VALLEY KING

KING CITY, ONTARIO

SITE GRADING PLAN

49

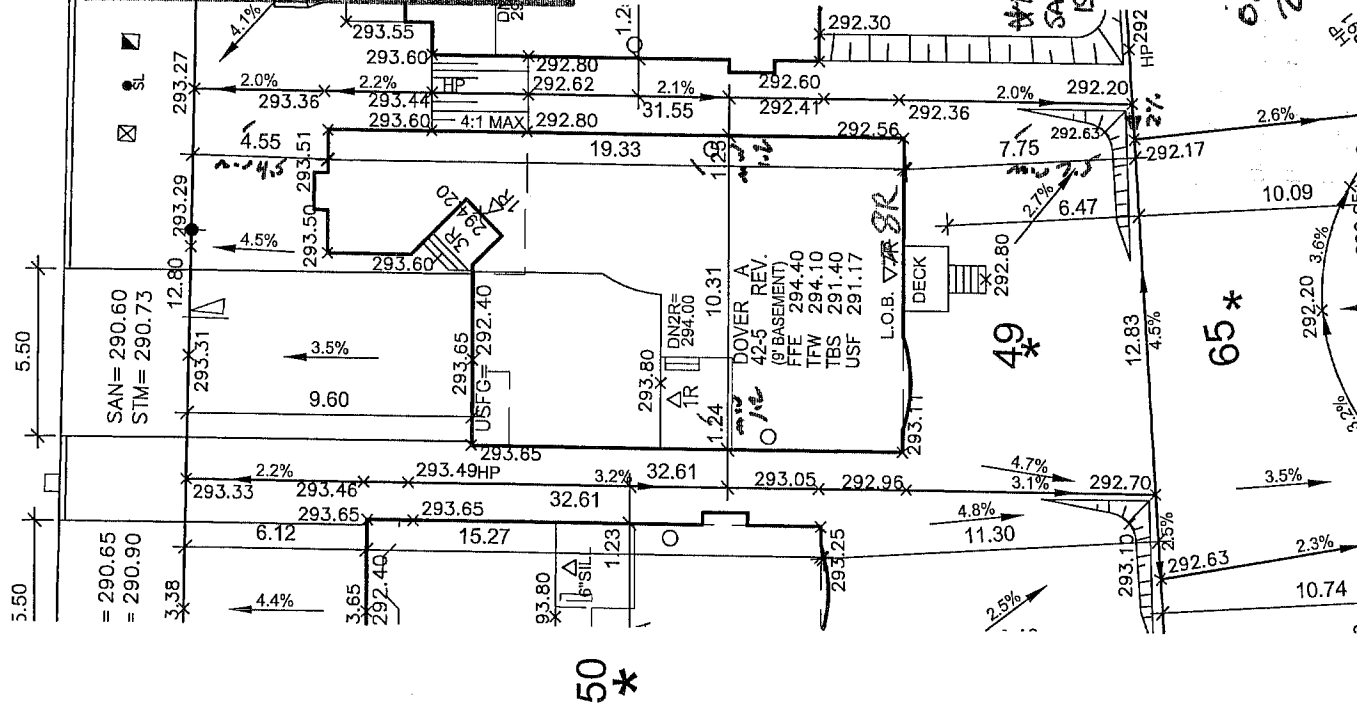
- ☐ REVIEWED WITHOUT CHANGES
- ☒ REVIEWED AS NOTED IN RED
- ☐ REQUIRES RE-SUBMISSION

NOTE:
SANITARY SERVICE
IS FLAT (2% MIN.)
